Service Bulletin No: 51-001

ATA Chapter: 51

**AIRCRAFT STRUCTURE - GENERAL****DO A CHECK OF THE MATERIAL SPECIFICATION USED DURING MANUFACTURE AND, IF NECESSARY, DO A CHECK FOR CRACKS OR REPLACE THE PART****1. Planning Information****A. Effectivity**

Nose Rib 1 - Inspection (If Necessary)  
Figure 3

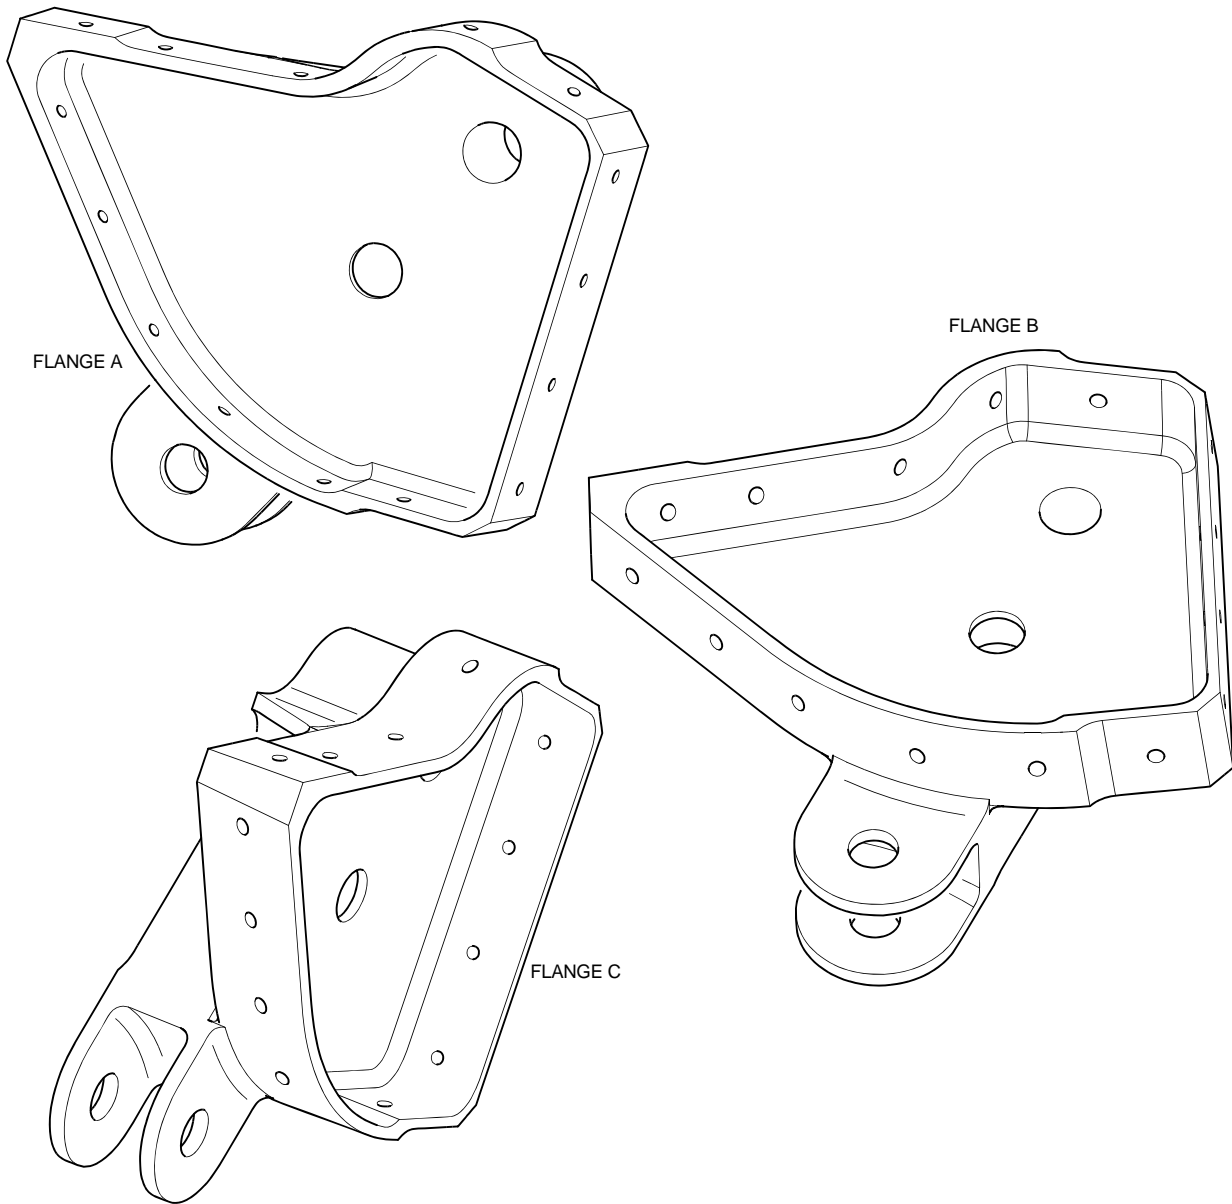
- (d) Do an inspection for cracks (Ref. Fig. 3):
- NOTE:** Step 3.B.(1)(d) is only applicable to aileron nose ribs made from AA2024-T351.
- NOTE:** Only personnel that are qualified and authorized by their designated Airworthiness Authorities are allowed to do this test.

- 1 Use the absorbent paper (Material No. P02-031) made moist with the solvent (Material No. P01-010) and remove the dirt and grease from the inspection areas of the left-aileron nose-rib 1 assembly (P/N 557.51.09.101).

- NOTE:** It is not necessary to remove the layers of surface protection to do the inspection.
- 2 Use a bright light source and a mirror to examine the inspection areas of the left-aileron nose-rib 1 for cracks.

- 3 If you find cracks:
- a You must contact Pilatus Customer Support before next flight. The address is:
- PILATUS AIRCRAFT LTD.,  
Customer Technical Support (MCC),  
P.O. Box 992  
6371 Stans, Switzerland

- Fax: + 41 (0) 41 619 67 73  
Email: Techsupport@pilatus-aircraft.com.
- b Make a report of the inspection results, refer to Step 3.B.(1)(e).
- 4 If you do not find cracks, make a report of the inspection results, refer Step 3.B.(1)(e).

Lower Rudder Bracket - Inspection (If Necessary)  
Figure 5

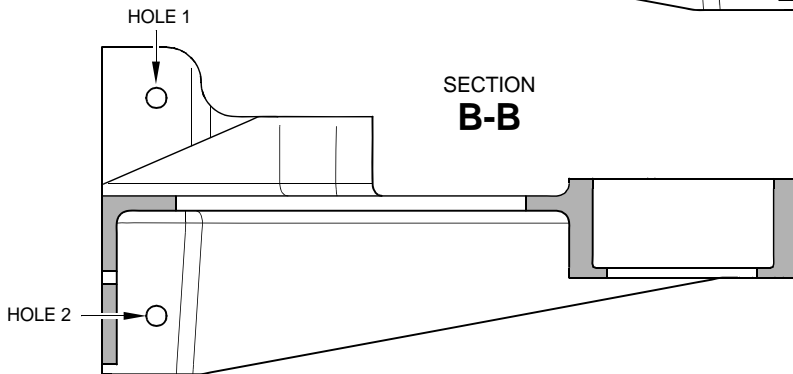
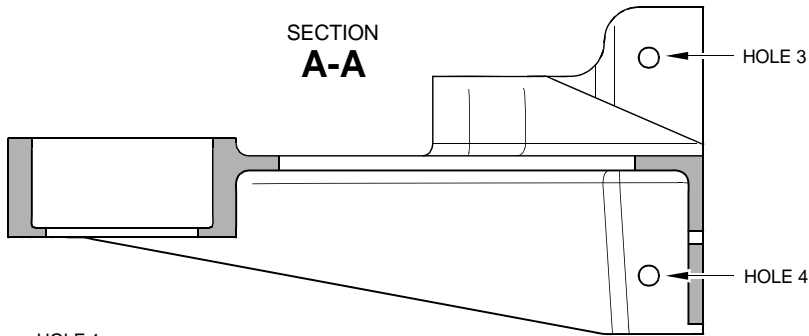
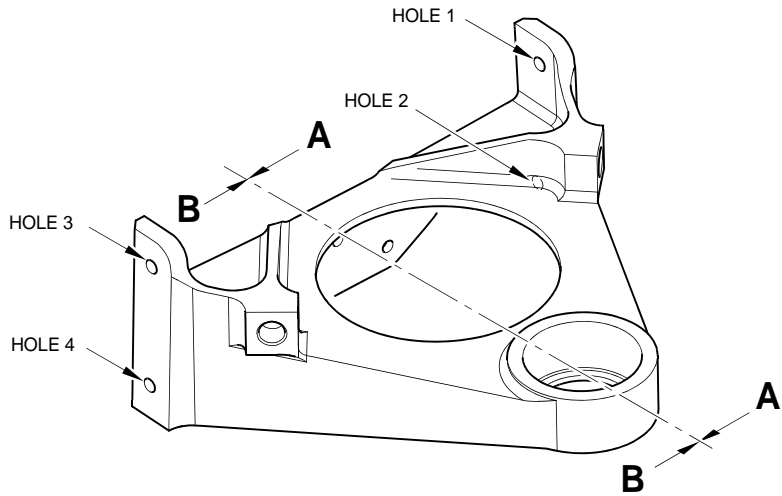
- 2 Remove the nuts (3), the washers (2) and the bolts (1) from the four attachment bolt holes of the rudder lower-hinge-bracket (4).

- 3 Use the absorbent paper (Material No. P02-031) made moist with the solvent (Material No. P01-010) and remove the dirt and grease from the inspection areas of the rudder lower-hinge bearing-bracket.

Inspection / Replacement of the Lever on the Rear Control Column  
Figure 13, Sheet 1 of 2

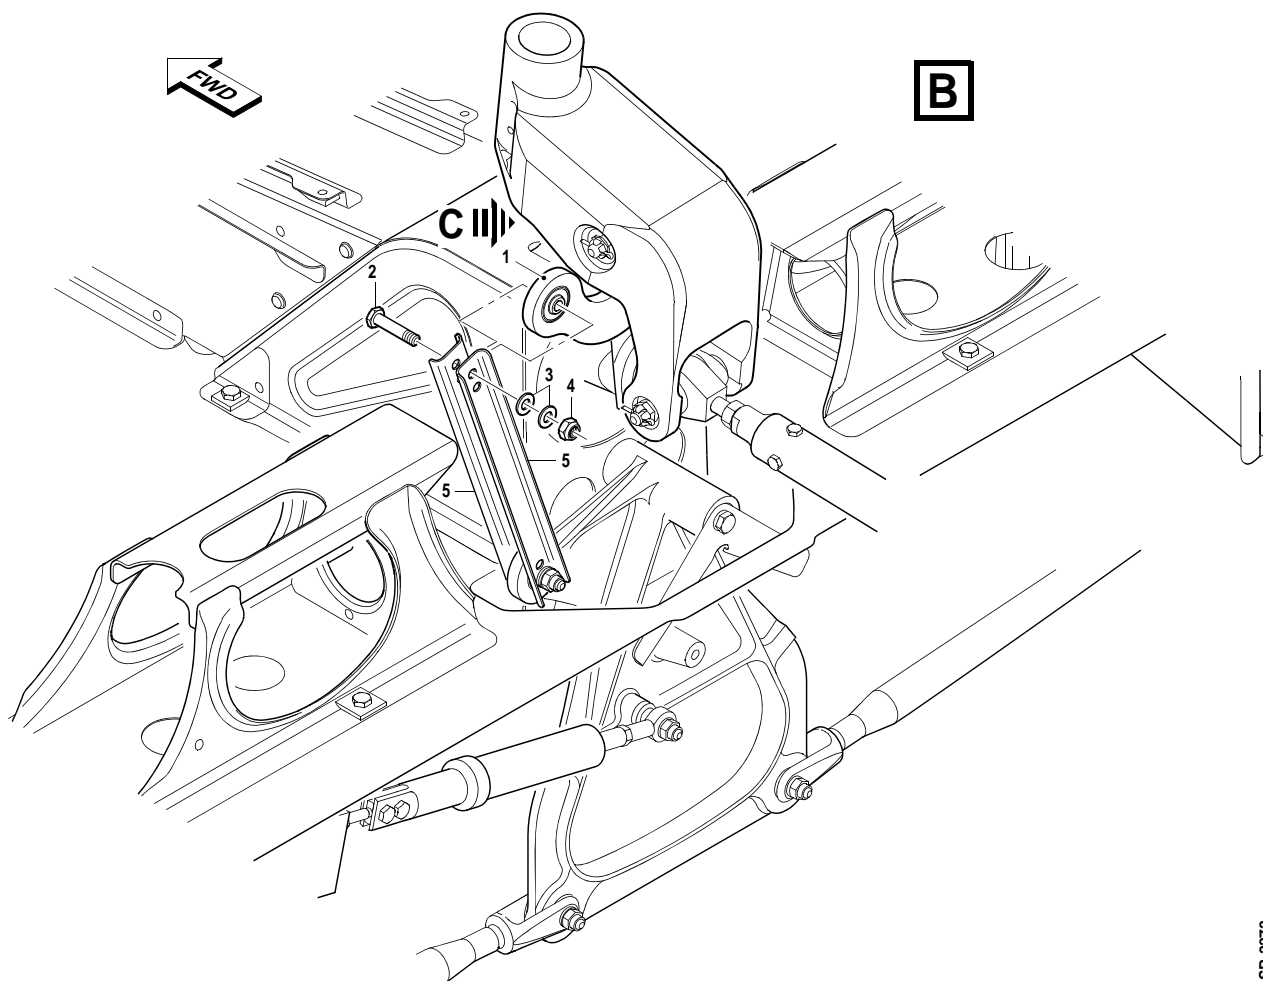
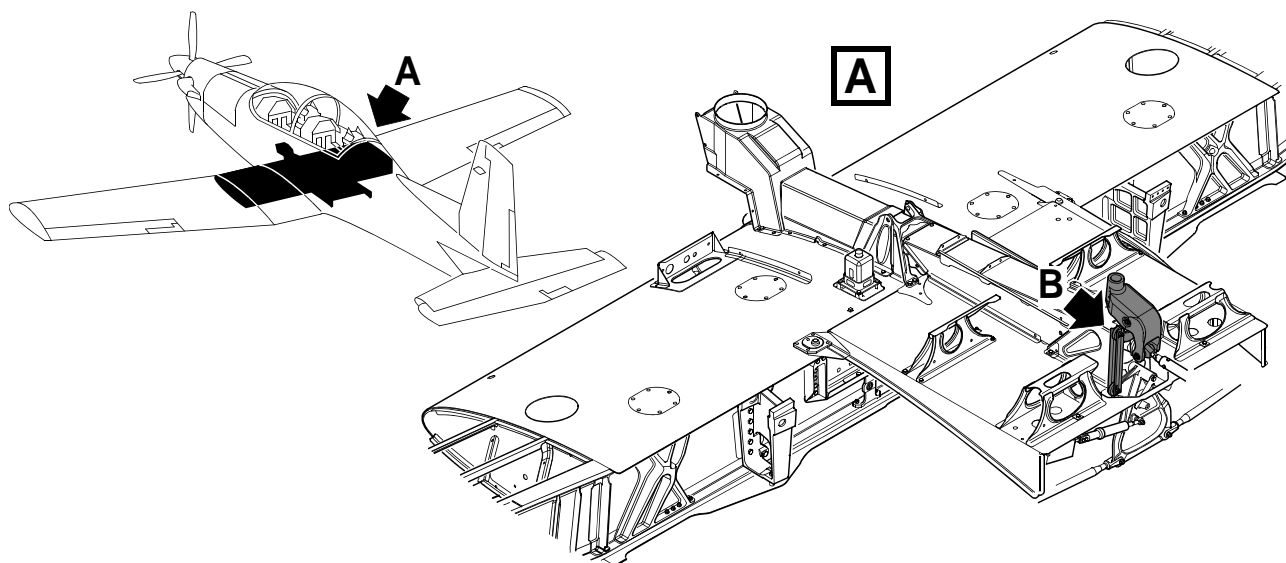
(d) Replace the lever (Ref. Fig. 13):

**NOTE:** Step 3.B.(6)(d) is only applicable to levers made from AA2024-T351.

1 Remove the nut (4), the washers (3) and the bolt (2).

- 2 Move the forward and aft channels (5) clear of the lever assembly, (1).
- 3 Remove, and discard, the cotter pin (19).
- 4 Remove the nut (20), the washer (18), the washer (14) and the bolt (13).

- 5 Disconnect the rear control column assembly (24) from the rod assembly (23).
- 6 Remove, and discard, the cotter pin (17).
- 7 Remove the nut (16), the washer (15), the washer (12) (if installed) and the bolt (11).

- 8 Remove the rear control column assembly (10) from the aircraft.
- 9 Remove, and discard, the cotter pin (9).
- 10 Remove the nut (8), the washer (7), the special washer (6) and the special bolt (21) from the rear control-column support-bearing bracket (22).

- 11 Remove, and discard, the lever assembly (1) from the aircraft.
- 12 Put the new lever assembly (1) (P/N 527.30.09.223) in position in the aircraft.

Replacement of the Bearing on the Forward Control Column  
Figure 14

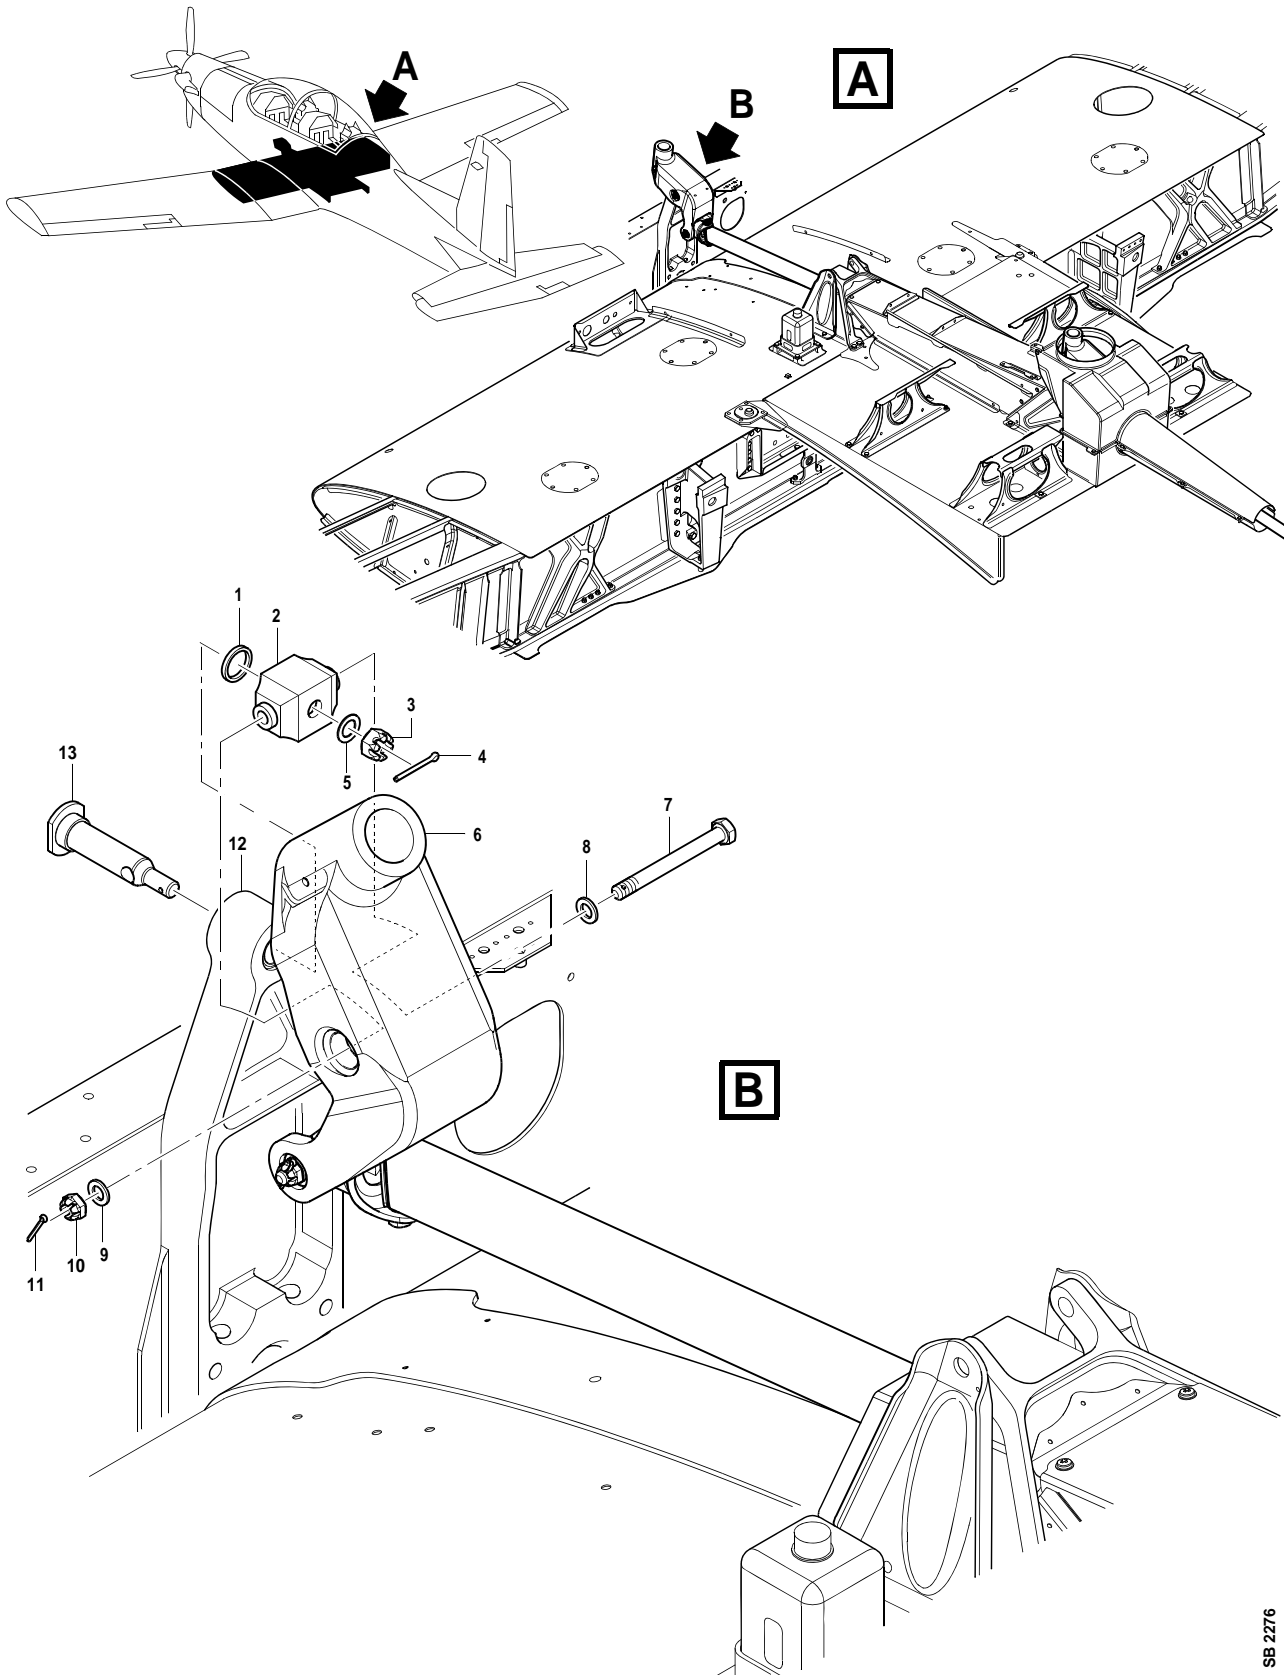
(d) Replace the bearing assembly (Ref. Fig. 14):

- 1 Remove, and discard, the cotter pin (11).
- 2 Remove the nut (10), the washer (9), the washer (8) (if installed) and the bolt (7).
- 3 Move the control lever assembly (6) towards the rear of the aircraft to get access to the bearing assembly (2).

- 4 Remove, and discard, the cotter pin (4).
- 5 Remove the nut (3), the washer (5), the special washer (1) and the special bolt (13) from the rear control-column support bearing assembly (12).

- 6 Remove, and discard, the bearing assembly (2) from the aircraft.
- 7 Put the new bearing assembly (2) (P/N 527.30.09.221) in position in the aircraft.
